DEVELOPMENT REVIEW BOARD
SUPPLEMENTAL SUBMITTAL

PROJECT NO. PR-2020-004747

Application No. SI-2021-00484

RESPONSES TO CITY COMMENTS

MARK	DATE	DESCRIPTION
ISSUE DATE:	—/—/—	
PROJECT NO:	221029	
CAD FILE:		
DRAWN BY:	EP	
CHKD BY:	SE	
COPYRIGHT:	S-E-A STUDIOS, P.C.	
SHEET CONTENT:	EXTERIOR ELEVATIONS

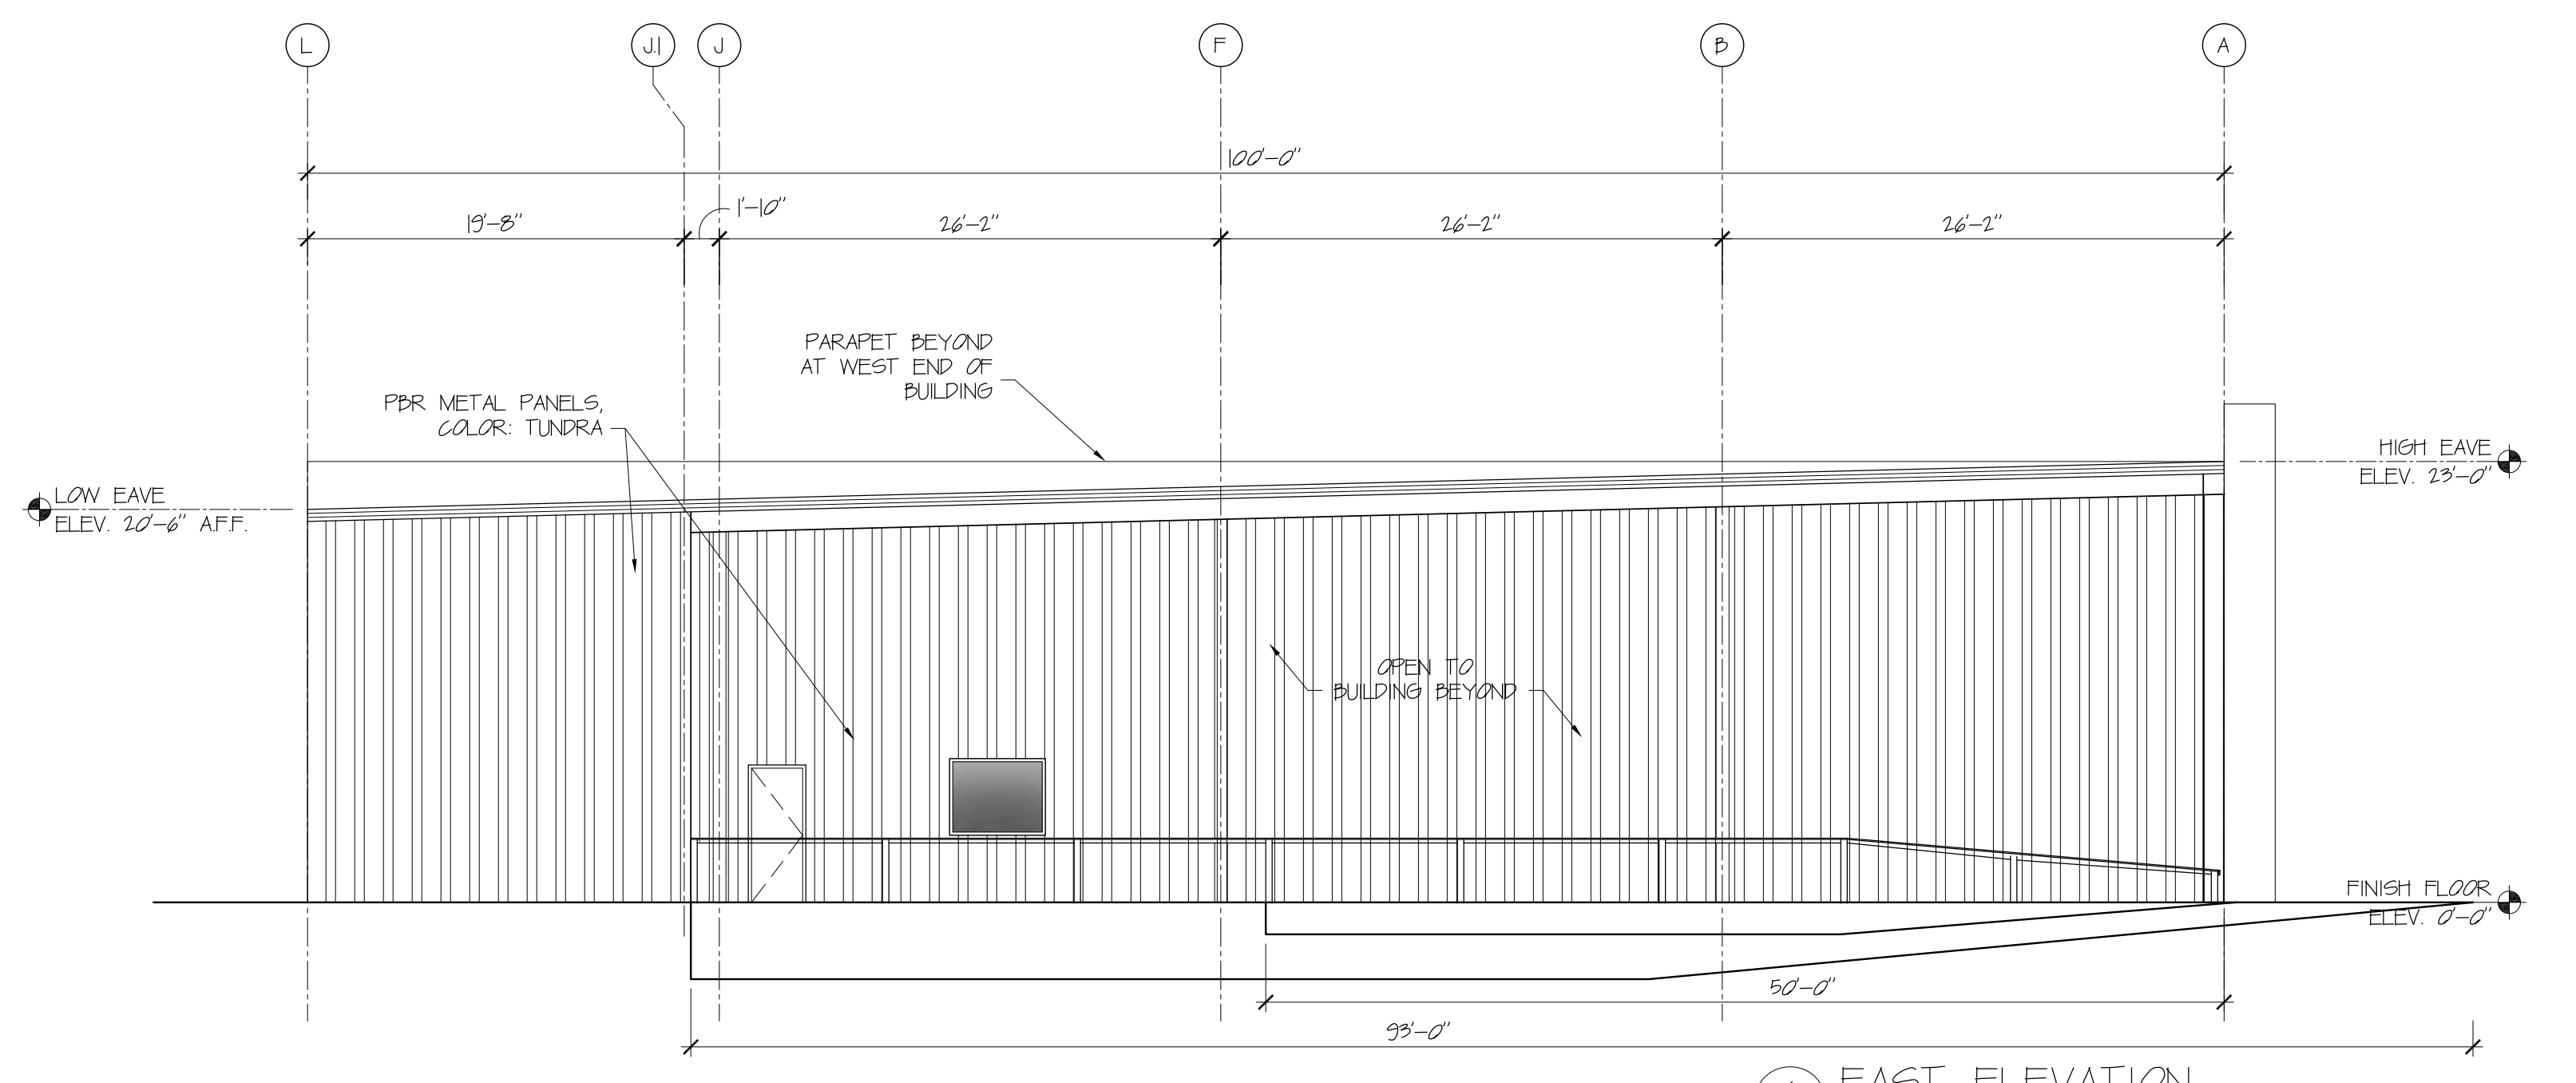
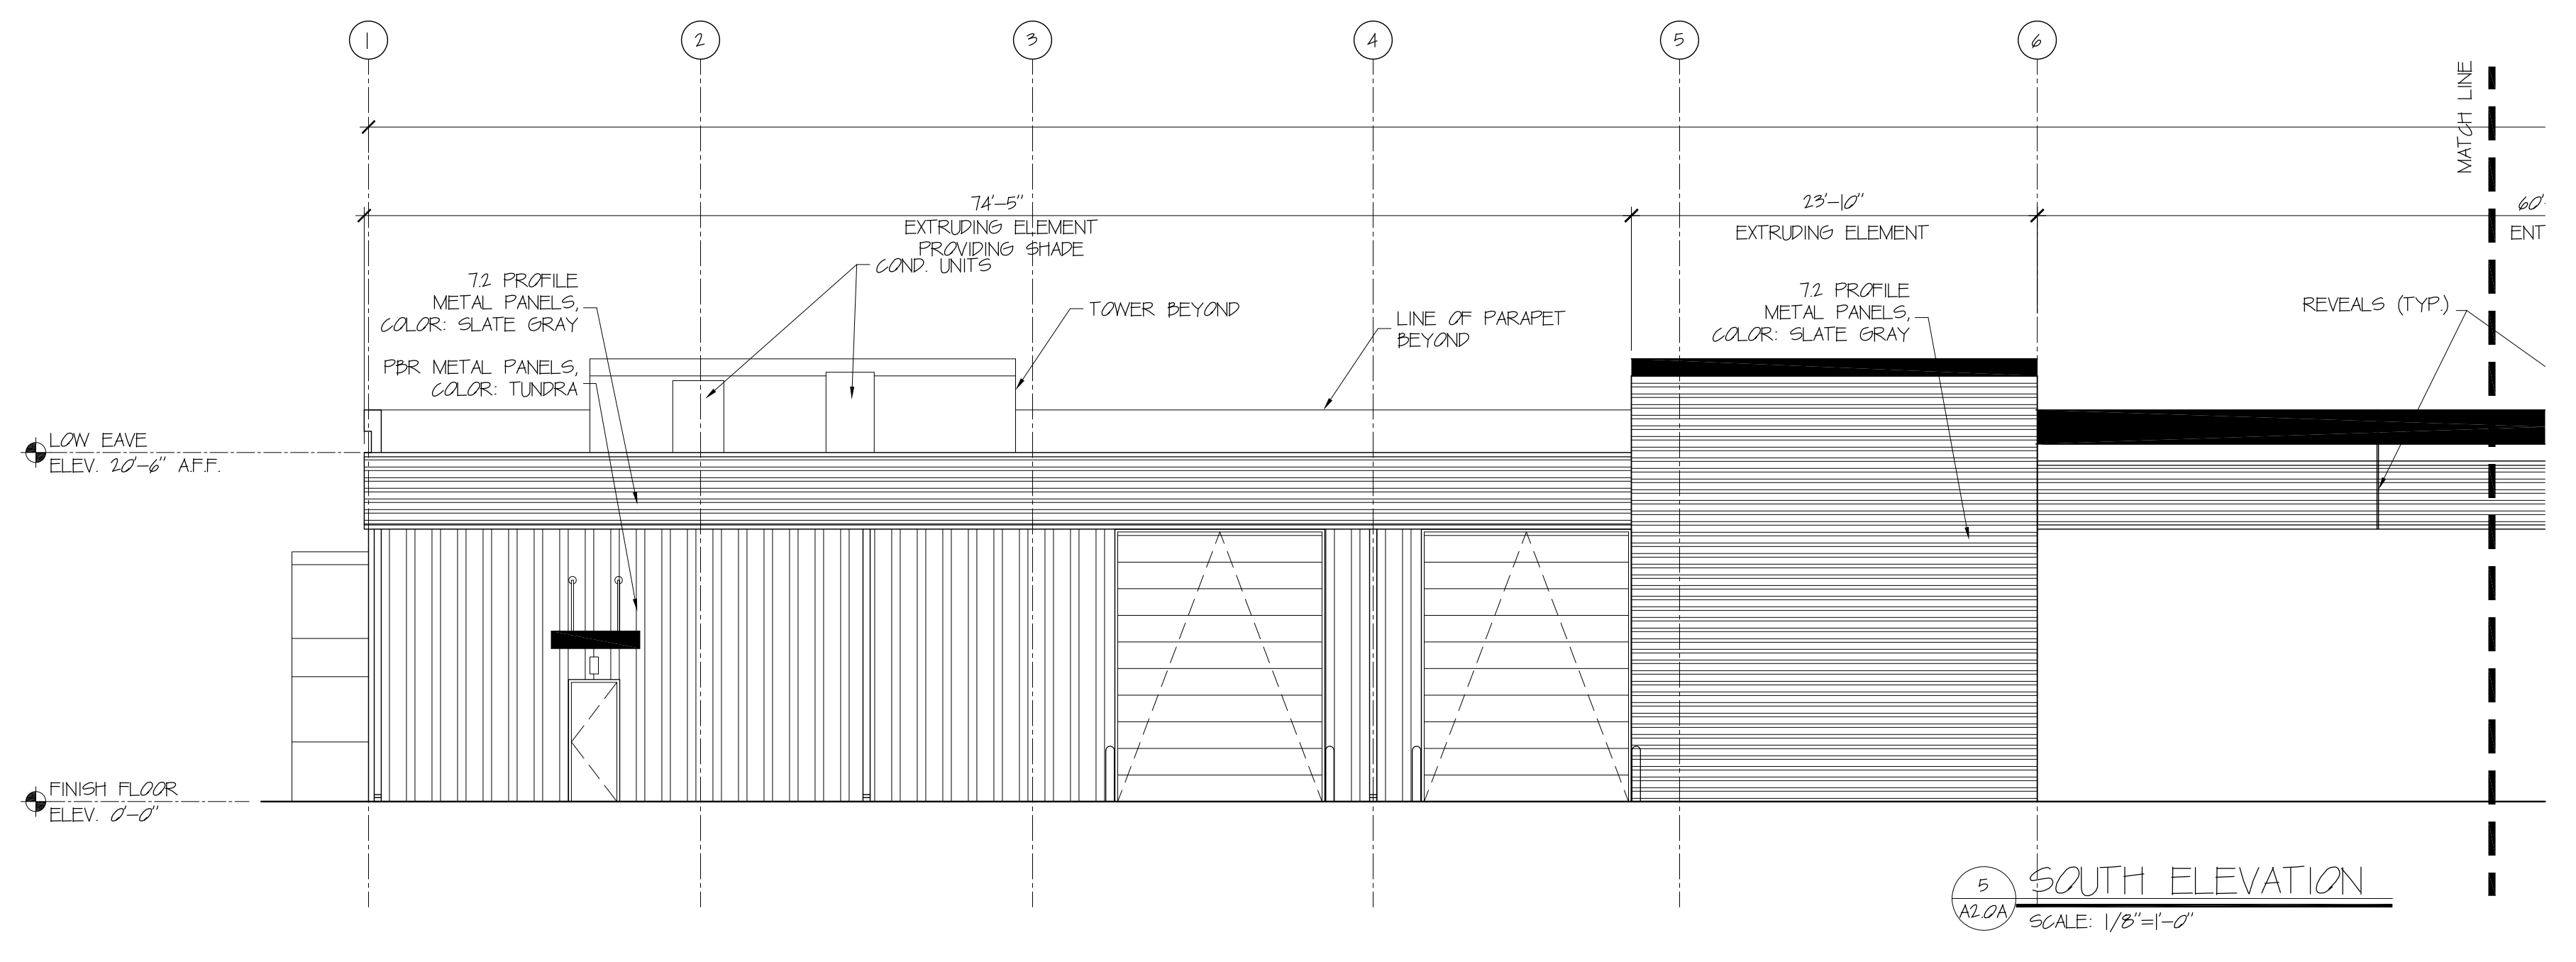
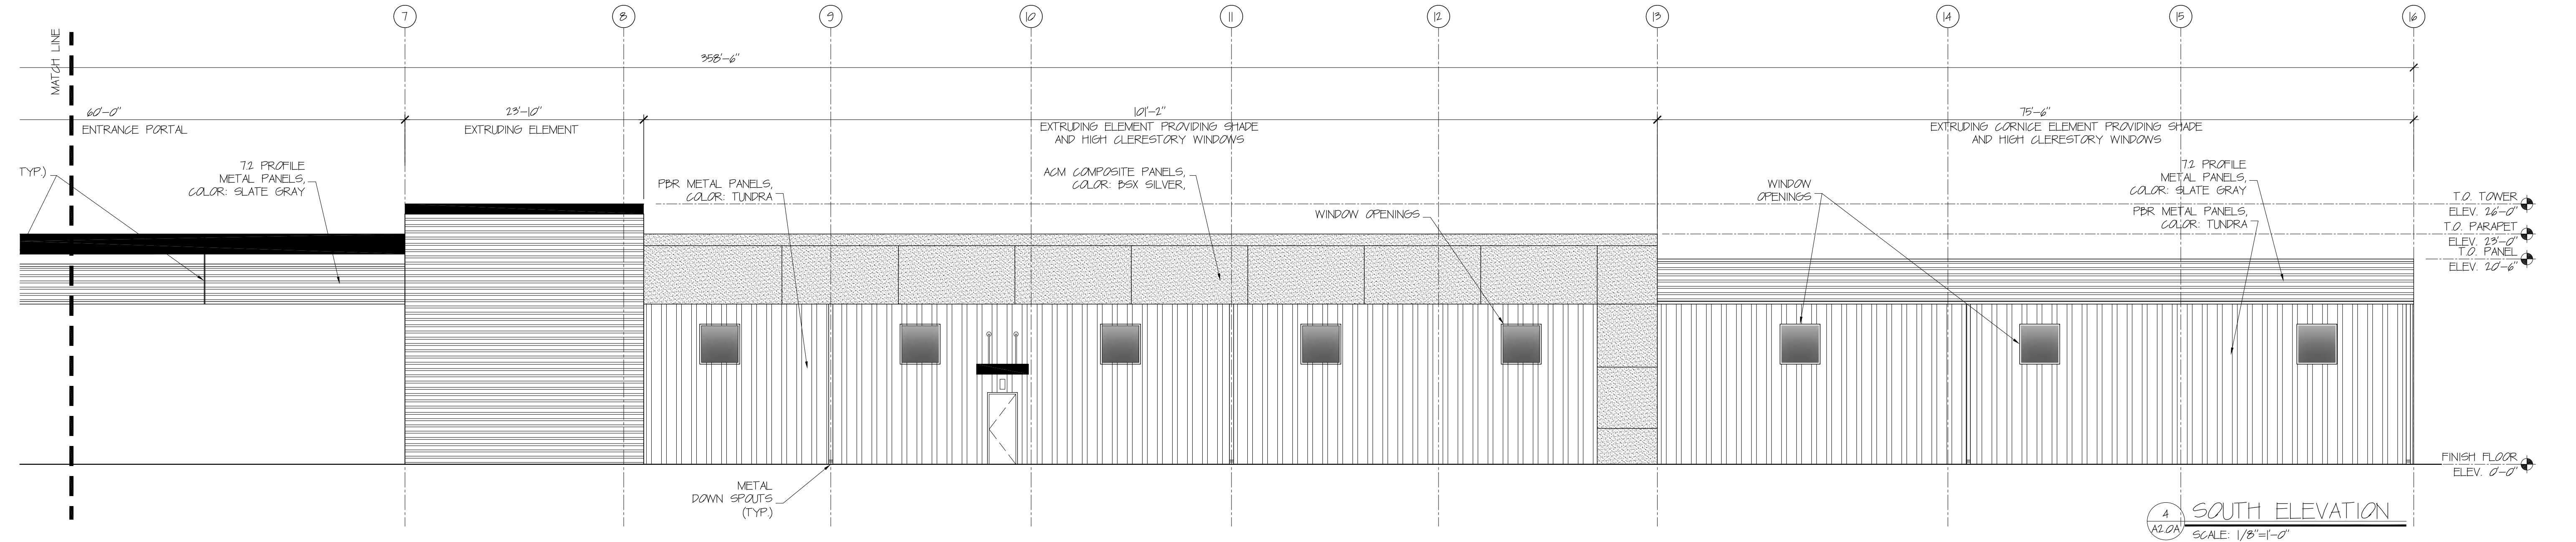
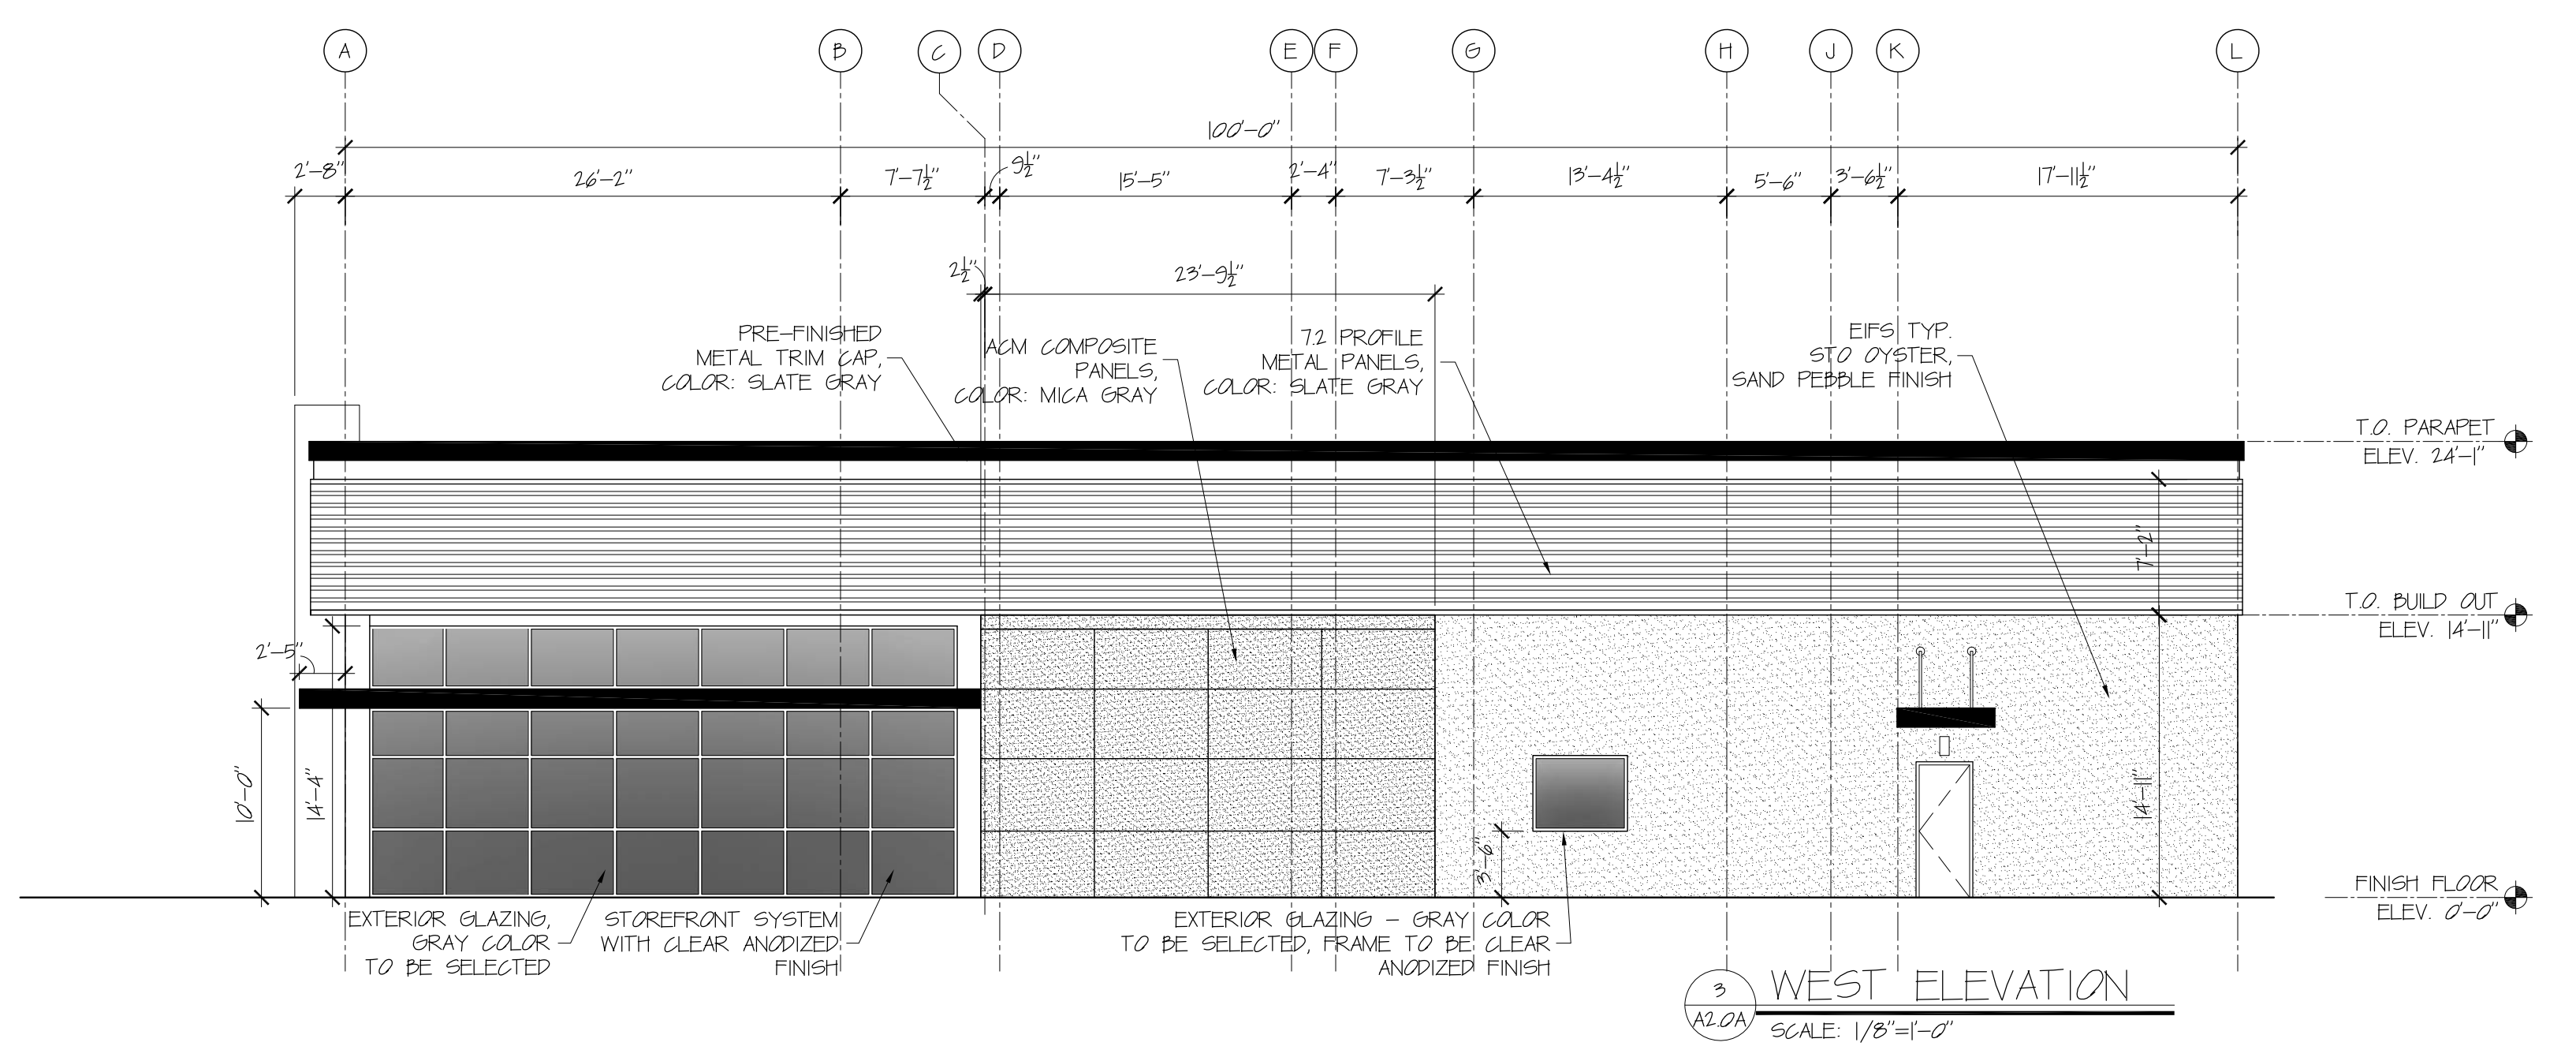
Elevation Review Comments:

The elevation needs to meet the following requirements:

1. Façades shall be designed to provide a sense of human scale at ground level by providing a clear architectural distinction between ground floor levels and all additional levels.

2. Each street-facing façade shall incorporate at least 2 of the following features along at least 30 percent of the length of the façade, distributed along the façade so that at least 1 of the incorporated features occurs every 40 feet.

3. Each street facing façade longer than 100 feet shall incorporate at least 1 of the following additional features.

- a. Wall plane projections or recesses of at least 1 foot in depth at least every 100 feet of façade length and extending for at least 25 percent of the length of the façade.
- b. A change in color, texture, or material at least every 50 feet of façade length and extending at least 20 percent of the length of the façade.
- c. An offset, reveal, pilaster, or projecting element no less than 2 feet in width, projecting from the façade by at least 6 inches, and repeating at minimum intervals of 30 feet of façade length.
- d. Three-dimensional cornice or base treatments.
- e. A projecting gable, hip feature, or change in parapet height at least every 100 feet of façade length.
- f. Art such as murals or sculpture that is privately-owned or coordinated through the City Public Arts Program

The North façade:

incorporates ground floor windows, primary entrance, high clerestory windows, portals, canopies and extruded wall elements providing shade. The total length of the façade is 358 feet and 9 inches. 30 Percent of the façade is 108 feet.

2a) Ground floor transparent windows occur along a total of 24 feet along the façade between column lines 1 and 3. Windows begin at floor level.

2b) Building has only one level, however high clerestory windows were placed 10 feet high between columns 8 and 13.

2c) Primary pedestrian entrance between columns 2 and 3.

2d) Entrance portals, canopies and extruding elements providing shade have been placed along a total of 310 feet along the façade length. See elevation. Arcades, trellises and awnings not provided.

The entrance portals, ground floor windows, high windows, primary pedestrian entrance, entrance portals, canopies and extruding elements occur along more than 30 percent of the building at least every 40 feet along the façade.

The South façade:

incorporates extruding elements, an entrance portal and high clerestory windows. The total length of the façade is 358 feet and 9 inches. 30 Percent of the façade is 108 feet.

2d) Entrance portals, canopies and extruding elements providing shade have been placed along a total of 310 feet along length of façade.

The entrance portals, high clerestory windows, entrance portals, canopies and extruding elements providing shade occur along more than 30 percent of the building at least every 40 feet along the façade.

The North façade:

3a) Wall plane projections or recesses of at least 1 foot in depth at least every 100 feet of façade length provided.

3d) Three dimensional cornice provided

3e) Change in parapet height every 100 feet of façade length provided.

See North elevation for change in parapet height every 100 feet.

The South façade:

3e) Change in parapet height every 100 feet of façade length provided.

See South elevations for change in parapet height every 100 feet.

At least 1 of the required elements has been incorporated along the north and south façades.
